# DOE Tank Removal Study

Hanford Advisory Board  
Tank Waste Committee

Vince Panesko

*November 3, 2011*

# Soil removal to 5 feet below tanks

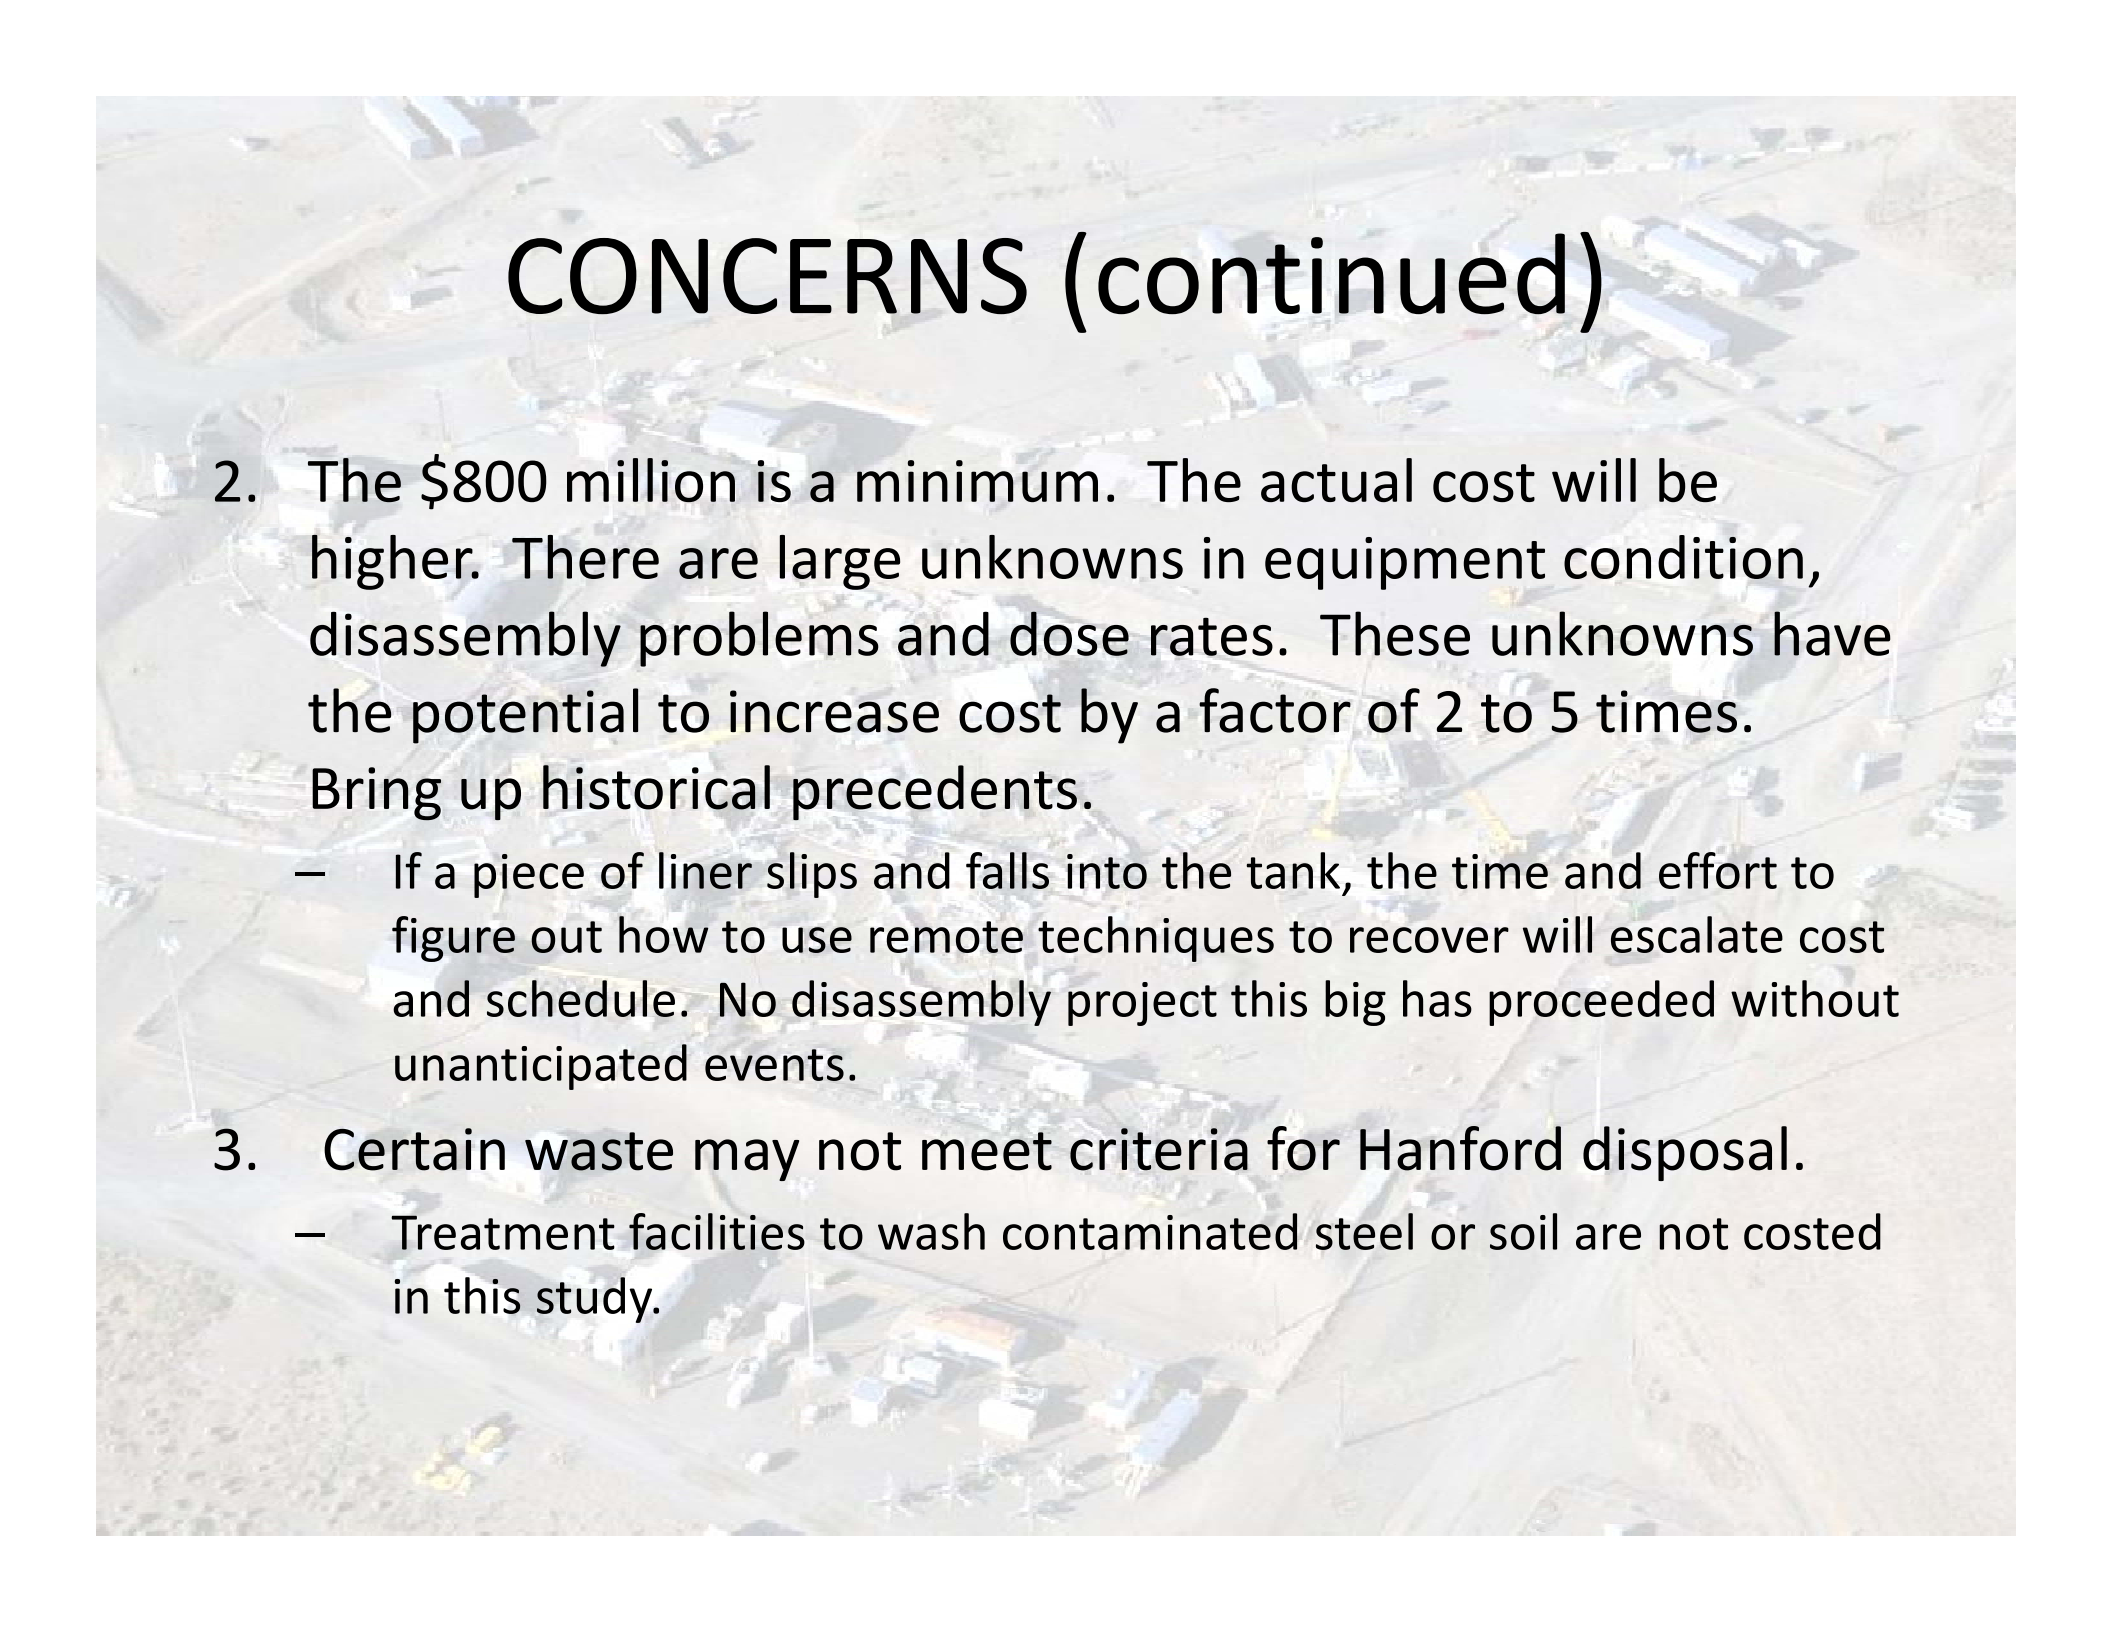
1. Does it make sense to spend \$800 Million to move about 46,000 curies of cesium-137 three miles to ERDF while leaving 59,000 curies of cesium-137 in the ground, especially when the lower vadose zone close to groundwater is considered more vulnerable than the curies on the waste residuals inside the retrieved tanks?
  - What has been gained? The TW&WM EIS and the Performance Assessment are expected to show little improvement in overall risk reduction to the public over 10,000 years
  - If the expenditure of \$800,000,000 does not significantly change the long term performance assessment of the 200 areas, what is the merit of proceeding with removing tanks but leaving the majority of cesium curies in the soil?
  - Should the excavation focus on going deeper to capture the 59,000 curies?
